**TOPIC: PUMP DRIVE PULLEY SPACER AND
PREMATURE CLUTCH FAILURE**

AFFECTED: IS5000Z/C31D, IS5000Z/C31DCE, IS5000ZC31D61CE
serial no. 101 - 200 (Pump Pulley Spacer Kit - # 49197)
serial no. 201 - 881 (Pump Pulley Spacer / Clutch Kit - # 49319)

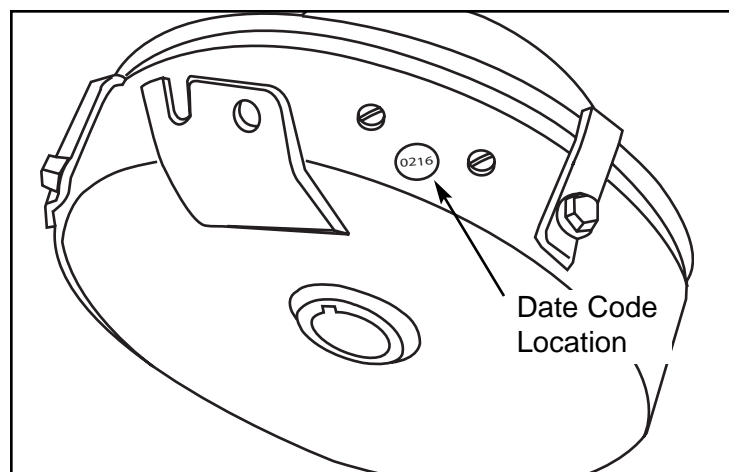
Field reports indicate an existing problem with premature clutch failure and Ferris Industries has also discovered a potential problem which can lead to loose fit condition between the pump drive pulley and the stub shaft.

To correct these problems, two kits have been created. Both kits include a new spacer and shorter key. The Pump Pulley Spacer / Clutch Kit also include a new clutch.

The clutch to be replaced will have a date code of 0216 thru 0341. See Illustration for approximate date code location.

Please note, this is a **MANDATORY REPLACEMENT**. Do not wait until the customer complains of a loose pump drive pulley or clutch issue, as additional service may be required to repair/replace worn or damaged parts.
